Addendum

1999 McClellan Air Force Base

**Basewide Volatile Organic Compound Feasibility Study
(VOC FS)**

June 2004

Figure 1 (Section 3.1)

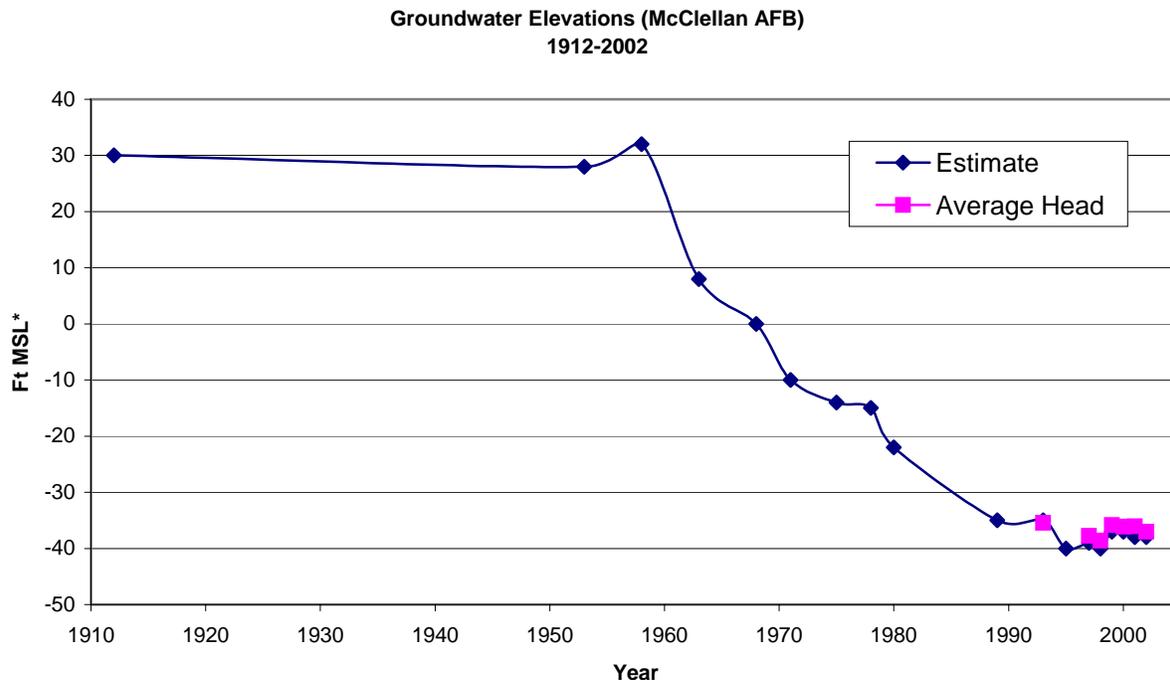
| Review Comments by: EPA (Joe Healy) | | |
|--|--|--|
| 11 | Page 10, Figure 1: Change the legend on the y-axis or add an additional legend on the other end of the graph using units of feet below ground surface (bgs) because this is what you introduced to the reader in the first paragraph of Section 3.1. Also, if you retain the MSL units, define them in the text or on the figure. | Figure 1 was modified accordingly. See Page 12 of the Draft Final Basewide VOC FS Addendum. |

| Review Comments by: DTSC (Kevin Depies) | | |
|--|--|--|
| 36 | Page 10, Section 3.2, second sentence: For clarity, we recommended substituting “ <i>are consistent with what is shown on Figure 1</i> ” for “ <i>basically agree with the ones that would be used with Figure 1</i> ”. | The text in Section 3.2 was modified to say: “Section 6.8 of the 1999 Basewide VOC FS presents a sensitivity analysis that has already considered the possibility of an earlier stabilization of the groundwater table at McClellan. Using those assumptions, which are consistent with what is shown on Figure 1 (Section 3.1), the time to achieve cleanup goals for Alternative 2b would increase from 147 years with a falling water table to approximately 500 years using the updated conceptual model of this Addendum.” |
